# COMMISSION OF ARCHITECTURAL REVIEW

## APPLICATION FOR CERTIFICATE OF APPROPRIATENESS

Address 908 N 24th Street

**RE: Commission of Architectural Review: 908 N 24<sup>th</sup> Street (E0000-428/001)**

**SHEET:**  
A3.1

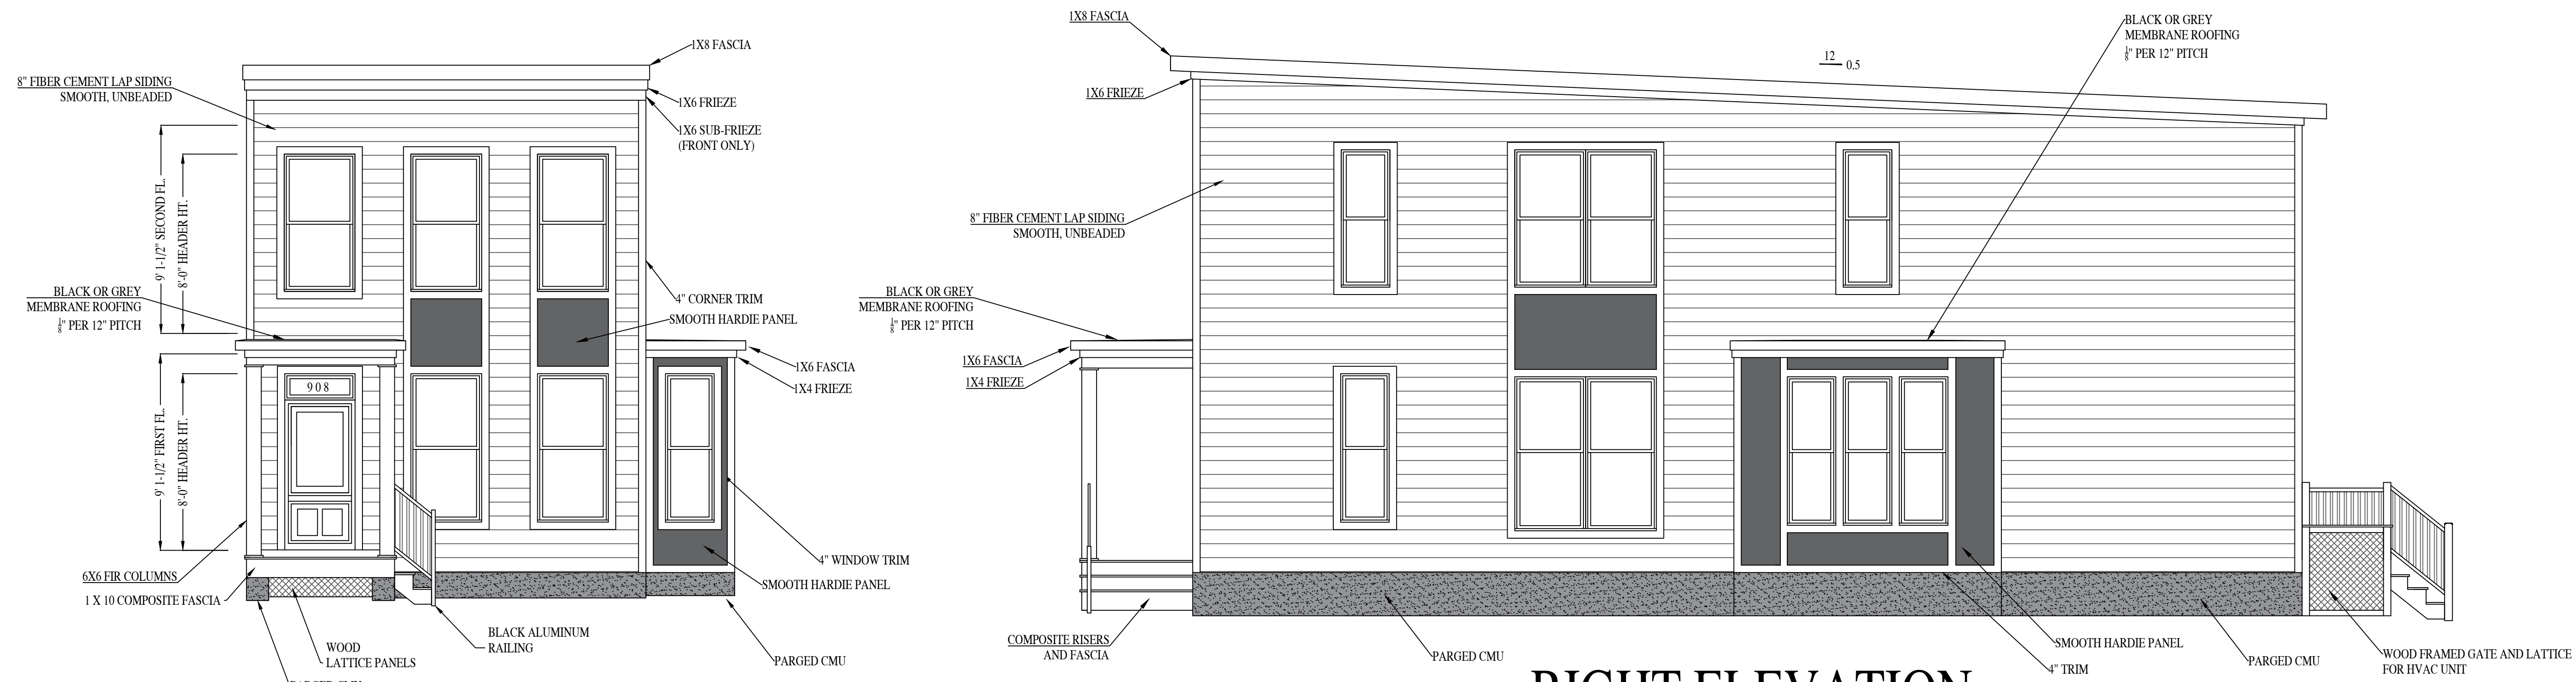
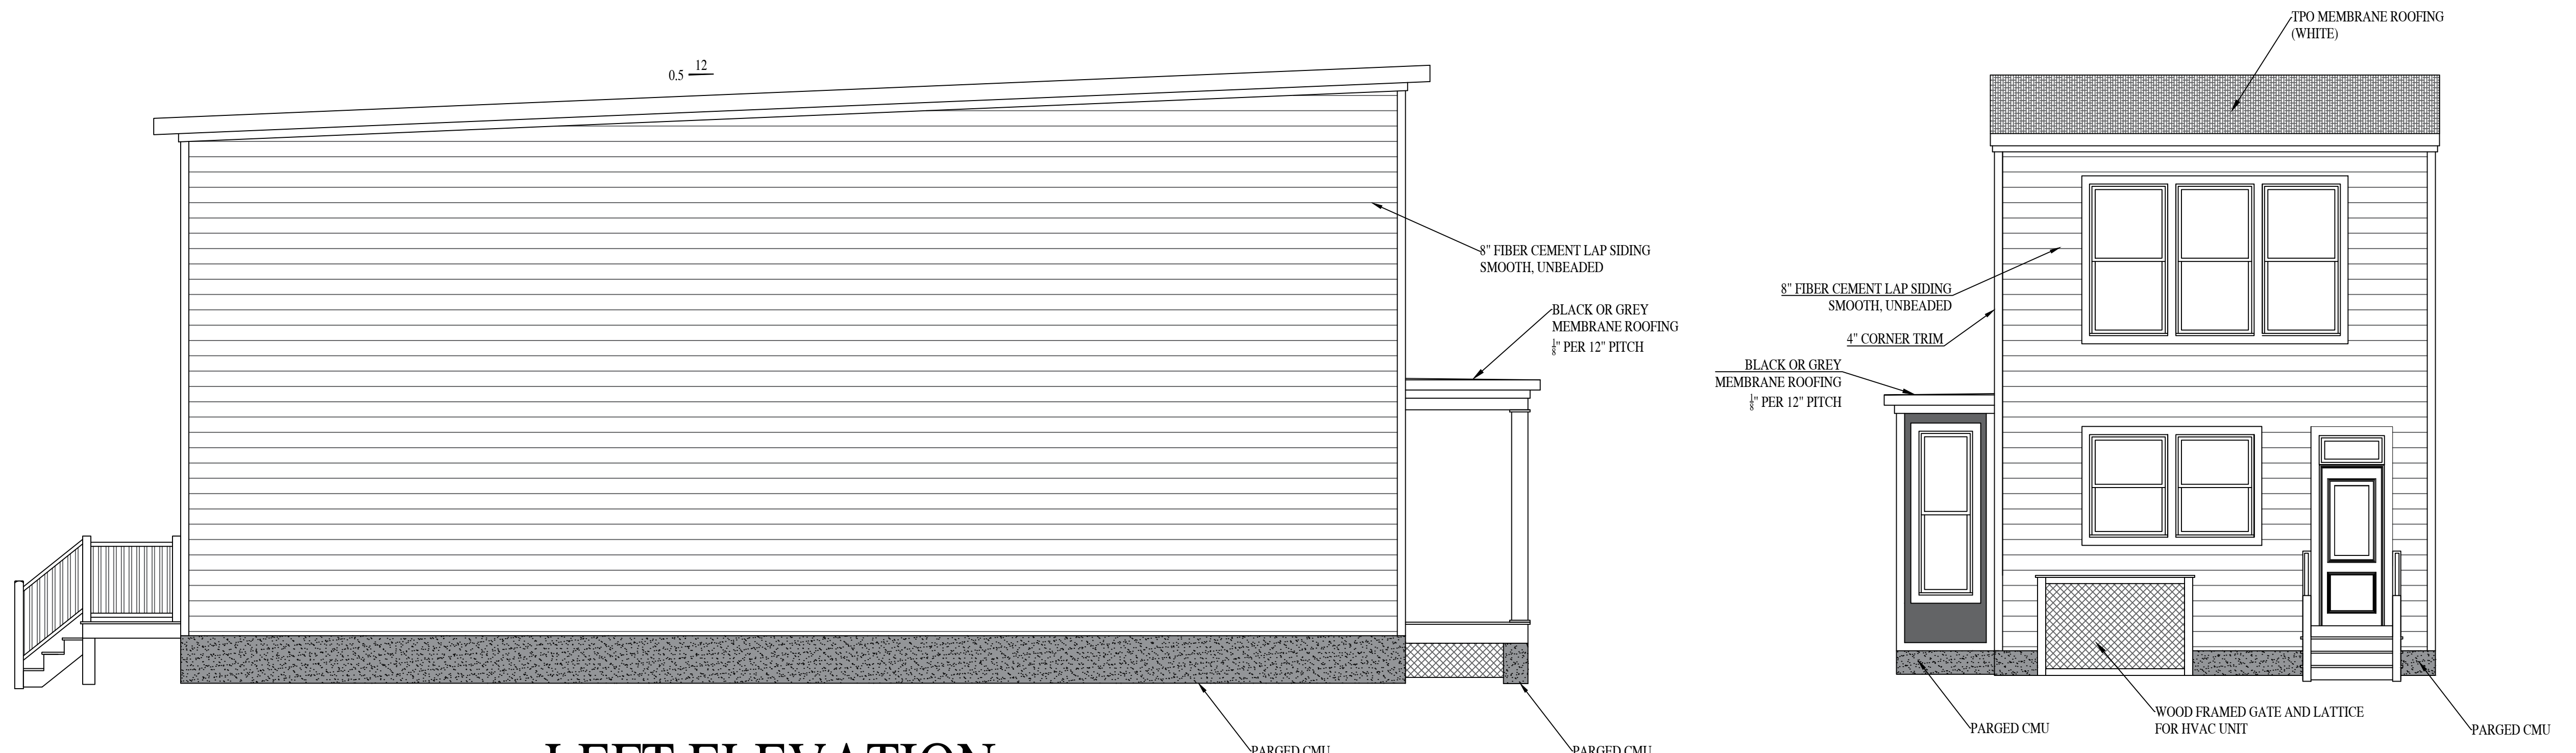
Section	Staff Comment	Response
Form, pg. 46, #3	Consider a full width porch	This was considered but the porch was not revised. Please see below discussion for further explanation.
Height, Width, Proportion, & Massing, pg. 47, #2	Reconsider the right-side elevation to create a more balanced window alignment and consider another first-story window to balance the fenestration pattern on the rear.	The window pattern on the right-side has been modified in order to be more balanced. An additional first-story window was provided on the rear façade as requested.
Height, Width, Proportion, & Massing, pg. 47, #3	Consider larger windows on the façade and a larger cornice line, including an additional trim board.	The first-floor windows have been increased in height from 6' to 6.5'. The cornice line is now larger with the addition of frieze boards. The truss height was reduced slightly and second floor windows were raised 8" to help reduce the spacing between window and cornice.

New Construction: Corner Properties – Residential, pg. 48	Staff recommends additional openings on the side elevations of the bay windows.	The bay has been made more substantial by increasing it in depth (12' x 4') and placing it on a foundation. Windows are now shown on the side of the bay as requested and an additional (3 <sup>rd</sup> ) window is shown on the bay's main façade.
Substitute Materials, pg. 60	Staff also notes the applicant proposes PVC on the columns, porch decking, and decorative panels between the windows. Staff recommends against the use of PVC for all of these elements as they are on highly visible elevations.	Panels between windows and on the bay are now shown as smooth Hardie panels. Columns are now show as fir.
Mechanical Equipment, pg. 68	Consider screening the HVAC unit	A wood frame and lattice enclosure with gate is shown for HVAC screening.

SHEET:  
 A2.1

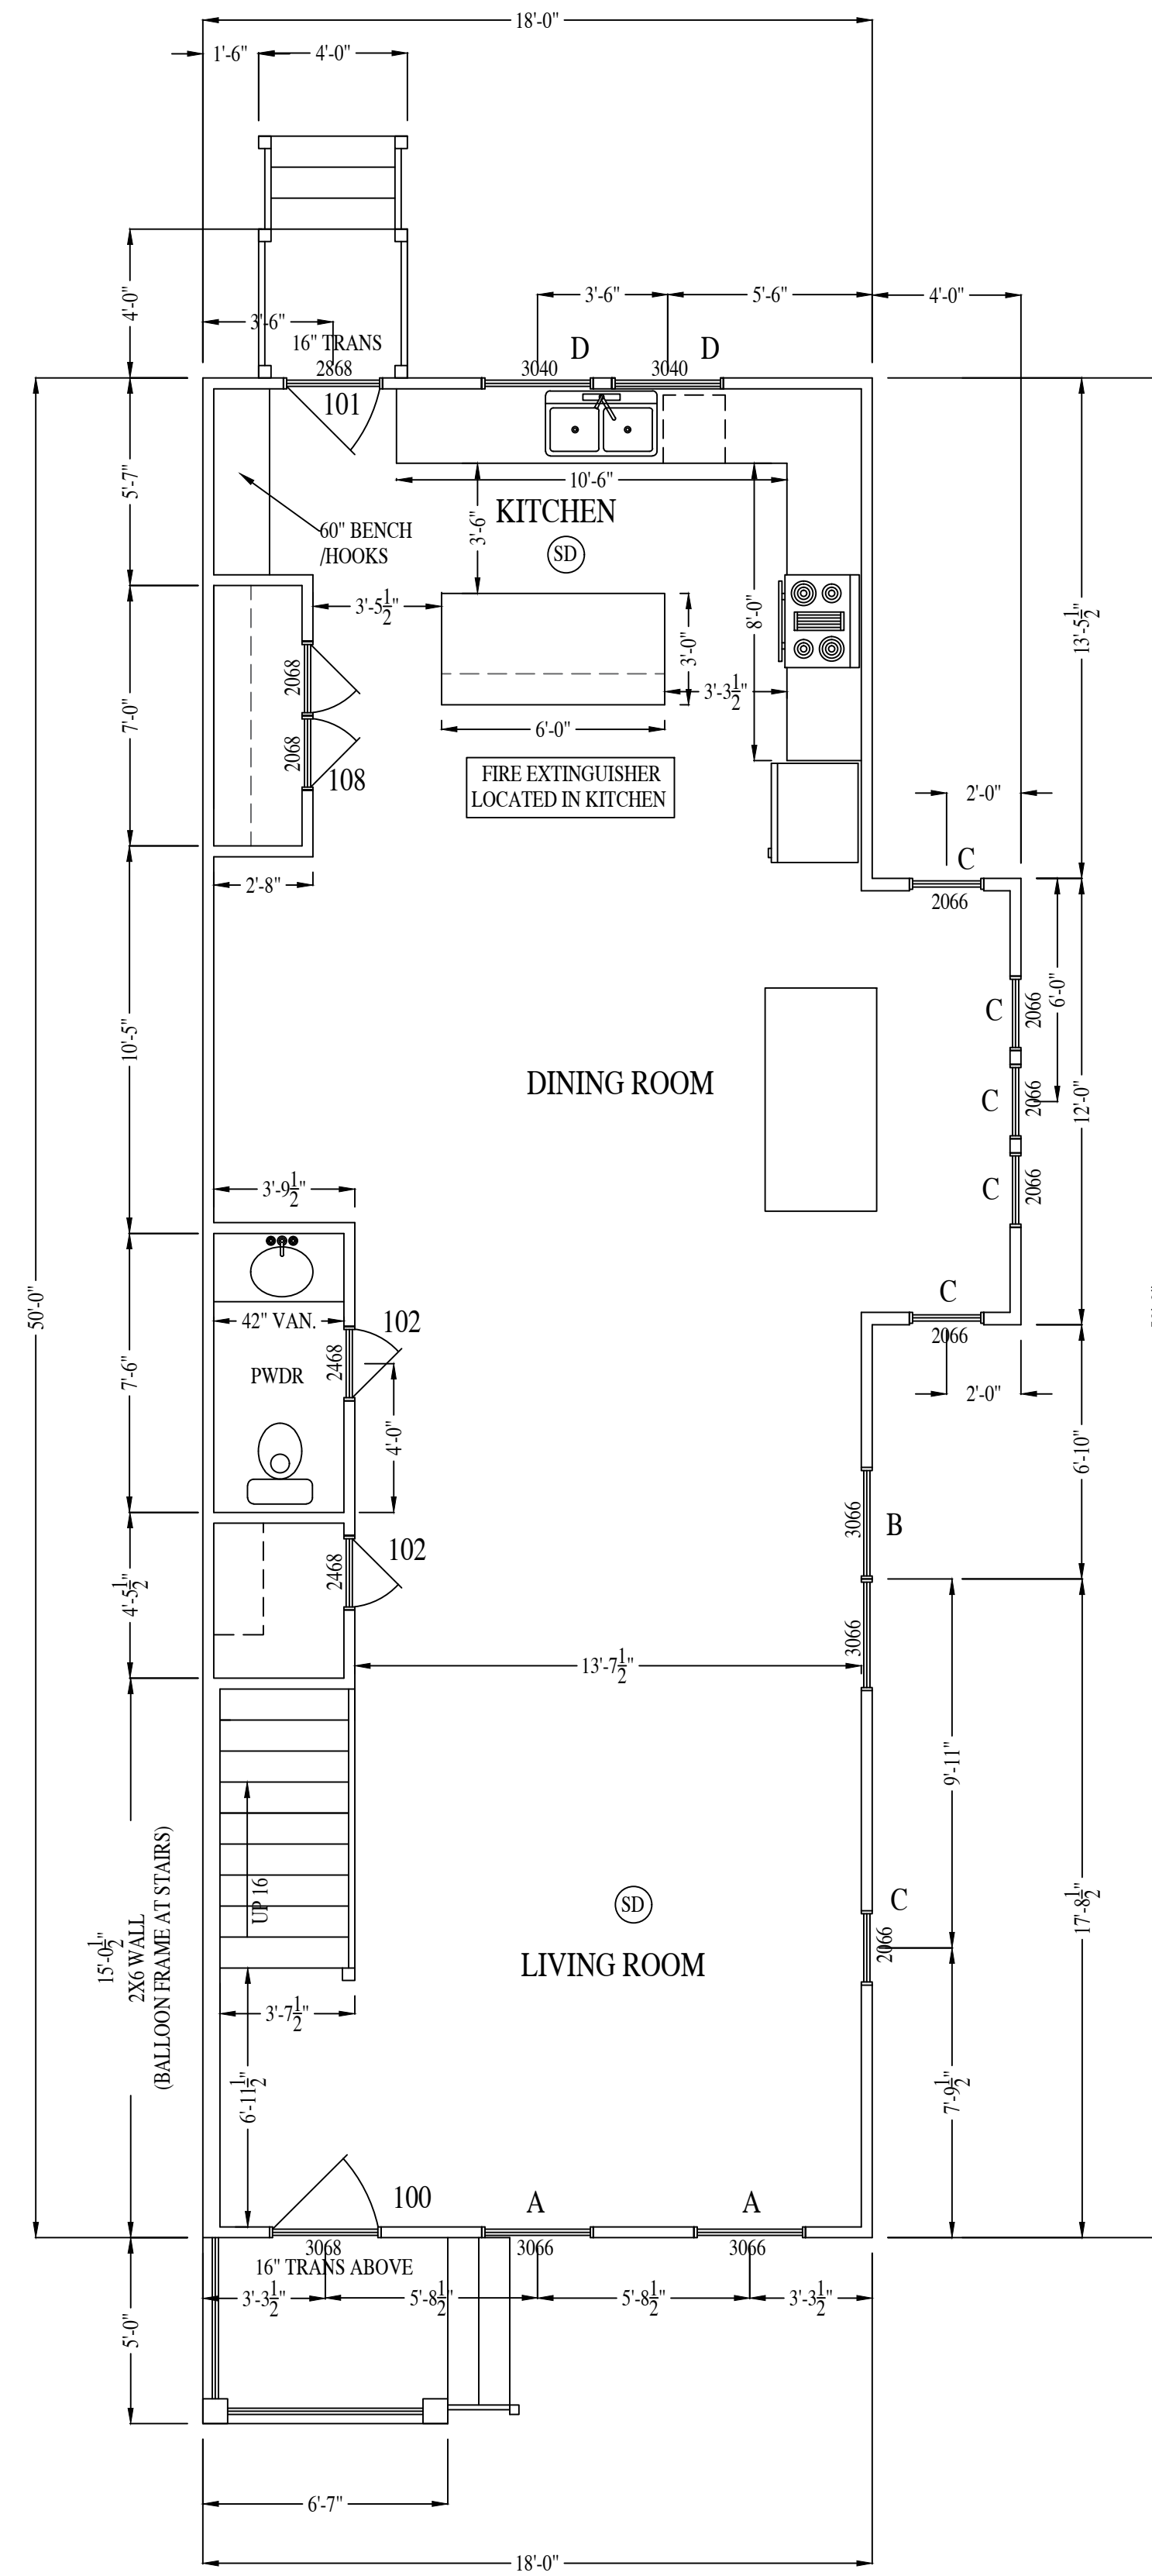
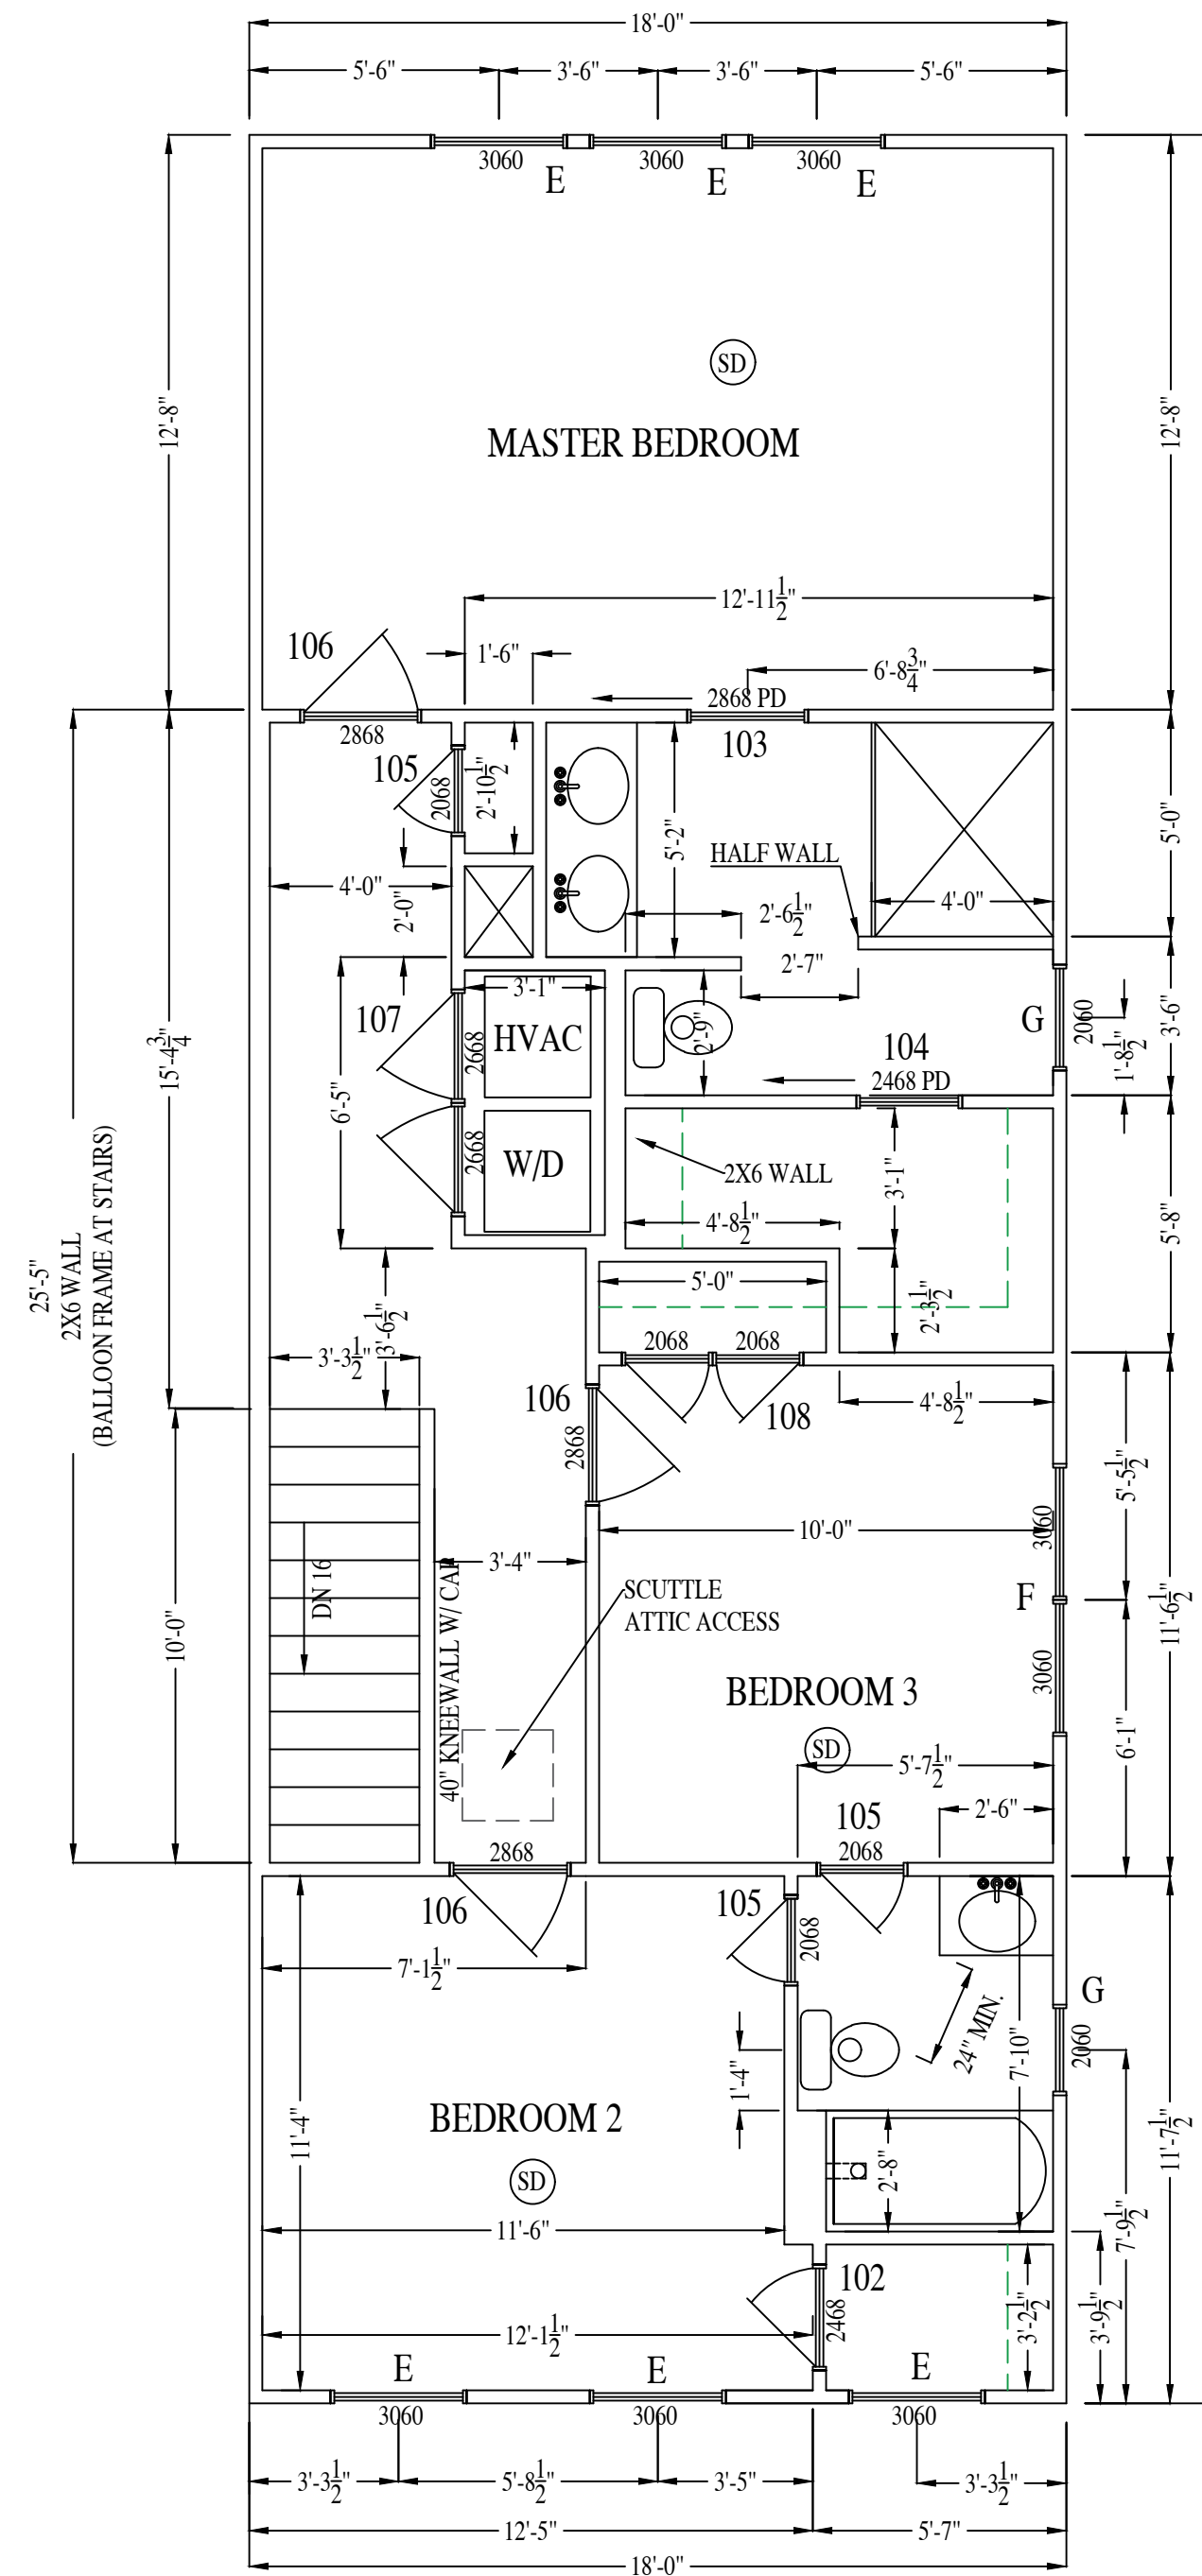
Materials and Colors, pg. 47, #2	The materials list indicates a parged foundation while the elevations show a brick foundation, and requests this be clarified in a subsequent application.	The plans now show parged CMU.
New Construction, Doors and Windows, pg. 49 #3	Consider a fenestration pattern in keeping with the surrounding area, including larger windows on the first floor, and submit a window schedule in a subsequent application.	Larger windows are provided on the first floor, increasing height from 6' to 6.5'. A window and door schedule is now included on Sheet A 2.1.
